ALERT SERVICE BULLETIN
Bell Helicopter **TEXTRON**

NO. 412-04-114

MODEL AFFECTED: 412 / 412EP

SUBJECT: TAIL ROTOR PITCH HORN ASSEMBLY
P/N 212-011-708-105, REPLACEMENT OF.

Figure 1
Correct Orientation of Pitch Horn Bushing

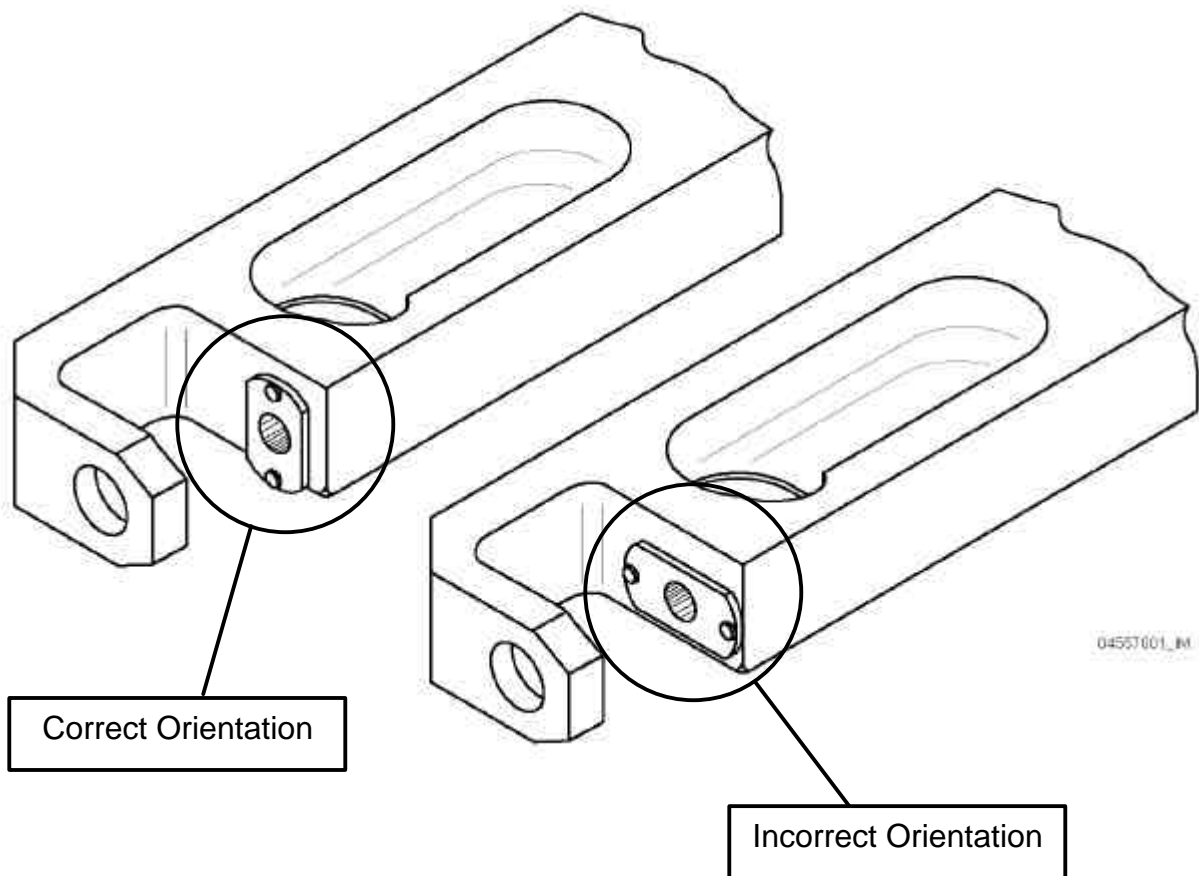
1. Review historical service records and physically identify T/R pitch horn serial numbers installed on aircraft and held in spares inventory.
2. For each horn found to be within the serial number block, verify position of bushing using Figure 1. If bushing is found properly positioned, add a letter "R" at the end of the serial number, using a vibrating stylus (For example: TI-113R).

3. If bushing is found incorrectly positioned in accordance with Figure 1, remove discrepant pitch horns, mating pitch links and attaching bolts (20-057-5-14D & NAS6605H20) and return to Bell Helicopter for credit. Remove any chordwise

4. Re-assemble Tail Rotor Hub & Blade Assembly as required by replacing discrepant parts with new and/or serviceable pitch horns, pitch links and attachment hardware between pitch horn and pitch link and crosshead to pitch link. Dynamic balance as required after installation.
5. All discrepant pitch horns serial number TI-1 through TI-113 that have never seen service on an aircraft may be reworked at Bell Helicopter. Reworked pitch horns will have a letter "R" at the end of the serial number.
6. Annotate historical records to show compliance with this bulletin.
